Talon Updates

Since the release of the 10' and 12' Talon Shallow Water Anchors in 2014 there have been a few minor design changes to improve some of the original components. These changes did not represent safety issues, but are an indication of an effort to continuously improve the reliability and performance of the Talon product line. **If the latest/current component part is not already installed then the installation of the current part(s) should be considered an “automatic” update.** This applies to both in-warranty and out-of-warranty units. We will honor warranty claims on all 3-stage Talon Shallow Water Anchors for these updates:

Figure 1. Lower Cable Tensioner Assembly

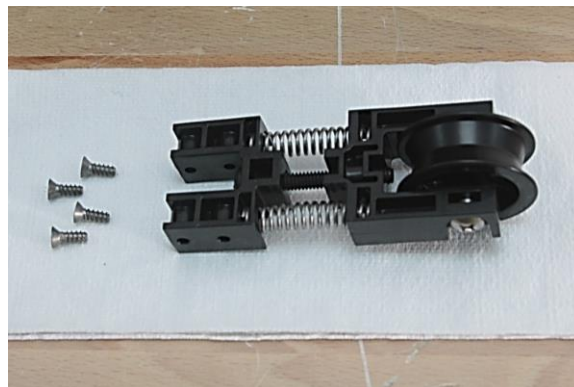
Cable Tensioner, p/n 2773630:

Beginning at serial number **O325MK** a lower cable tensioner replaced a fixed lower pulley to reduce the possibility of a cable coming off of any pulley internally. In addition to improving Talon function it will be necessary to install this in place of the lower pulley to reassemble the Talon as the tools to reassemble it with a fixed pulley are not going to be made available.

Figure 2. Second Stage Wiper Assemblies

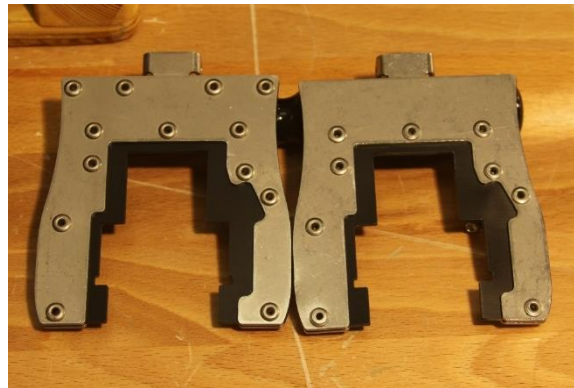
Second Stage Wiper, p/n 2884618:

On some early units the bottom plate of the second stage wiper was pealed back. To remedy this a row of rivets was added to the leading edge of the second stage wiper assembly beginning around serial number **O183MK**. Correct wiper assemblies have a total of thirteen (13) rivets, the previous version had nine (9) rivets. Any units that still have the wiper assembly pictured on the right in fig. 2 should be updated to the current second stage wiper assembly.

Figure 3. Spike Isolator Assembly w/Wipers in Cross Section

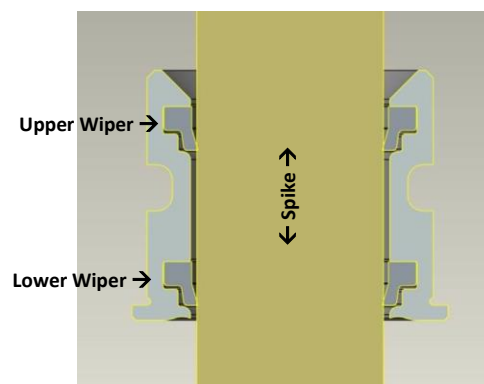
Spike Isolator Wiper ASM, p/n 2778825:

To further prevent mud and debris from entering the Talon the Spike Isolator was modified to include a flexible wipers that will remove more material from the Spike during retraction. This change began with serial number **P266MK**. The wipers are trapped in grooves in the spike isolator, this change is not visible externally, Figure 3 shows a cross section of the new wiper assembly with the spike in place.
